ZONE	Tourist Accommodation
PLANNING SCHEME	Douglas Shire Planning Scheme 2018 version 1.0
REFERRAL AGENCIES	There are no referral agencies for this application
NUMBER OF SUBMITTERS	Two (2) to the original public notification in 2006
STATUTORY ASSESSMENT DEADLINE	10 July 2018
APPLICATION DATE	12 June 2018

That Council approves the application for minor change to approval for the combined application for a material change of use and reconfiguration of a lot (33 lots & common property) with a House on each lot and a display home over land described as Lots 41 & 42 on RP747344 and Lots 49 & 51 on SP161464, located at 4-10 and 9 Escape Street, PORT DOUGLAS, subject to the following:

**Staged Reconfiguration Development
of Escape Street Land
Cancelling Lots 41 & 42 on RP747344 & Lots 49 & 51 on SP161464
Escape Street, Port Douglas**

PROJECT	BOTANICA PROJECT, PORT DOUGLAS
TITLE	TYPE C - PLANS & ELEVATIONS
SCALE	1:200 @ A3
DATE	SEPT 05
JOB NO.	0515
DWG NO.	ARCH
REV	A

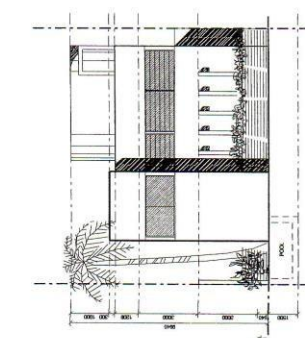
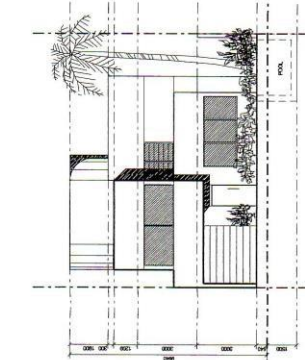
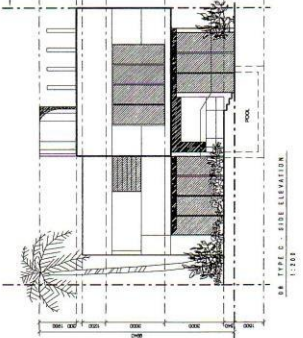
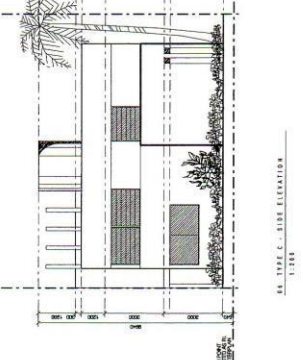
- (b) The maximum height of any building is nine (9) metres ***excluding roof structures***. ~~The structures on the roof terraces of dwelling type C will need to be reduced in height to below nine (9) metres. The only permitted roof structure on dwelling type C is over the proposed stairwell.~~

(c) House roof designs shall be re-designed to adopt pitch roof designs consistent with Council's current Planning Scheme Policy – Building Design and Architectural Elements.

The design of the buildings remain the same as in the approved form apart from replacing the flat roof designs with pitch roof designs on each House in order to make the designs reflect tropical design elements consistent with Planning Scheme Policy SC6.2- Building design and architectural elements.
